Product Change Notification / LIAL-15QPNY176

CCB 4506 Final Notice: Qualification of MMT as an additional assembly site for selected products available in 8L TDFN (2x3x0.8mm) package.

CCB 4506
Pre and Post Change Lead Frame Comparison
PCN # LIAL-15QPNY176

Lead frame comparison

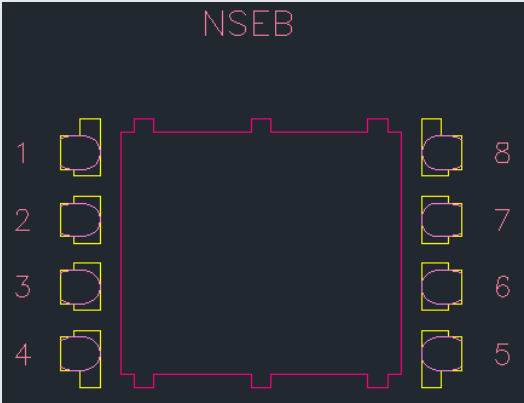
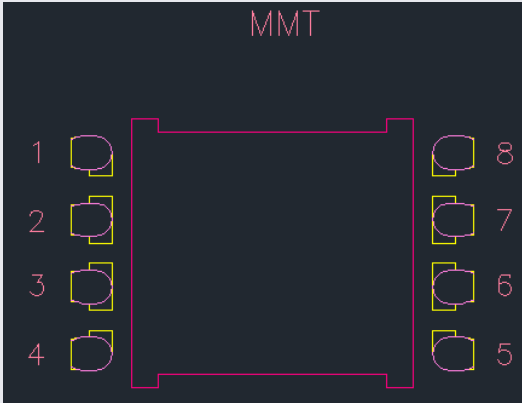
Assembly Site	UTAC Thai Limited (UTL-1) LTD. NSEB		UTAC Thai Limited (UTL-1) LTD. NSEB		Microchip Technology Thailand (Branch)/ MMT
	Au	CuPdAu	Au	CuPdAu	CuPdAu
Wire material	8200T	8600	8200T	8600	3280
Die attach material	G700LTD		G700LTD		G700LTD
Molding compound material	A194		A194		A194
Lead frame material	No		No		No
Lead Frame Lead Lock

April 7, 2021: Issued final notification. Attached the Qualification Report. Provided estimated first ship date to be on April 15, 2021.**April 13, 2021:** Re-issued final notification. Corrected the lead frame lead-lock from Yes to No.
